Rezoning Transportation Analysis

Petition Number: 2022-139

Revision Log:

Date	Description
1-25-23	First Review (TM)

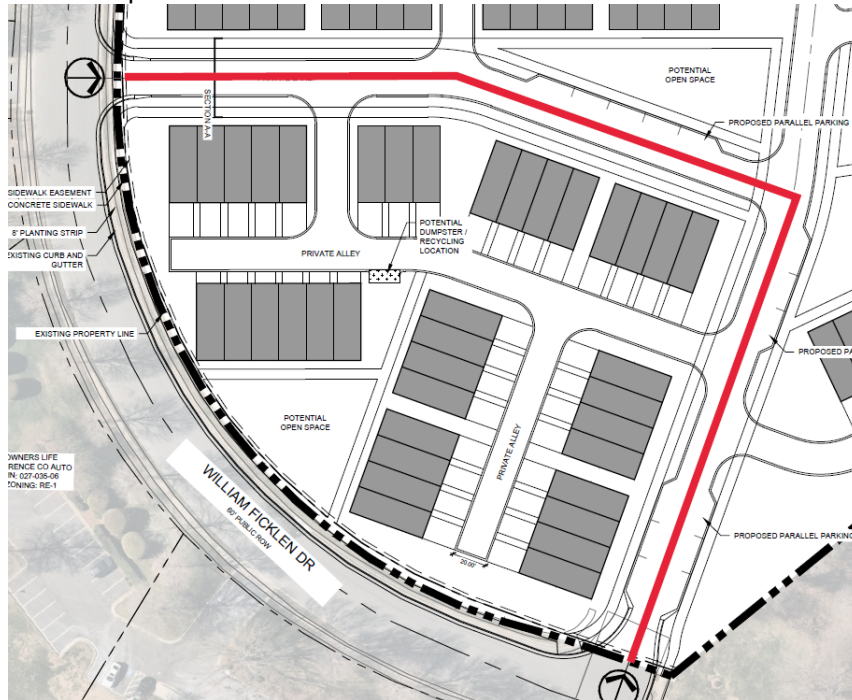
3. Revise conditional note(s) to commit to construct an 8-foot planting strip, and 6-foot sidewalk on Road William Ficklen Drive per Chapter 19. The site plan shall label and dimension both items from the back of curb and gutter or edge of pavement.

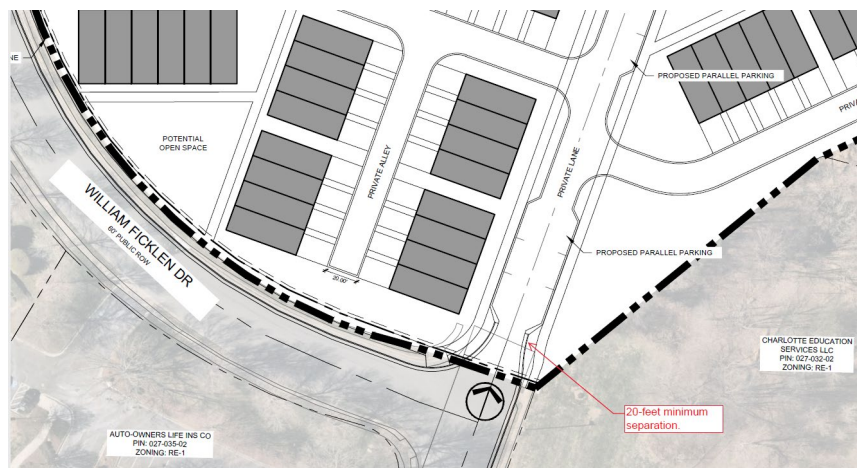
6. Revise site plan and conditional note(s) to commit to revising the internal private North/South and East/West "private lane" to be constructed to public street standards, with appropriate cross section, as network required streets per coordination with Subdivision.
